# City of Mississauga Department Comments

Date Finalized: 2024-08-22	File(s): A374.24 A375.24 Ward: 1
To: Committee of Adjustment	
From: Committee of Adjustment Coordinator	Meeting date:2024-08-29 1:00:00 PM

### A374/24

**Property Address:** 876 and 878 Atwater Ave

### Appendix 1 – Transportation and Works Comments

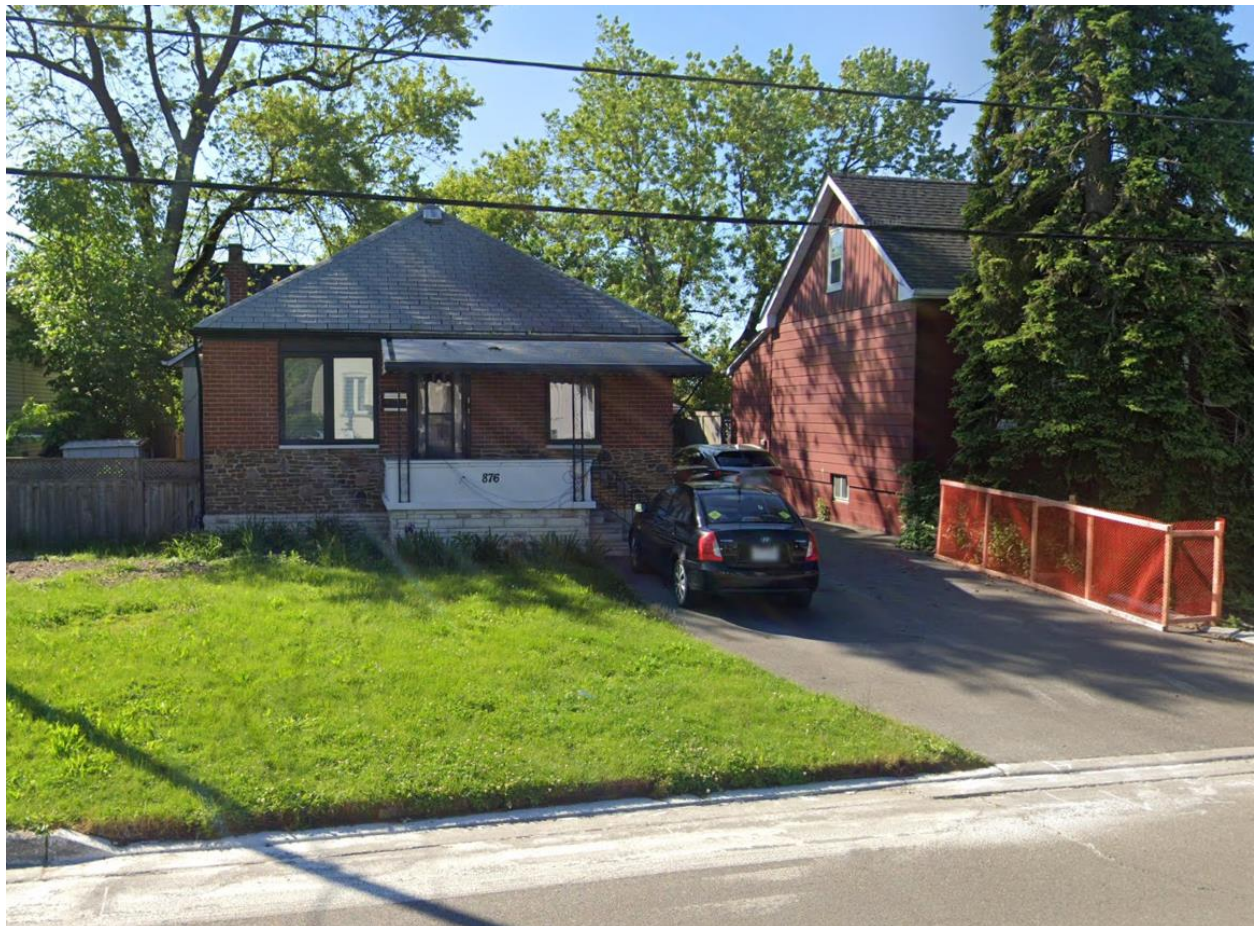
This Department cannot support variance #4 for a window well setback of 0.6m. Our Development Construction Section had previously reviewed and approved a grading BP 9NEW 24/2074 for the proposed semis which did not contemplate any window wells in the side yards.

The plan include a retaining wall along both of the exterior side yards for drainage purposes. The inclusion of window wells in the side yards would impede the overall drainage pattern that was initially proposed.

We would also question how the home owner would even access the rear yards of each dwelling with the presence of the 3 window wells and the required retaining wall.
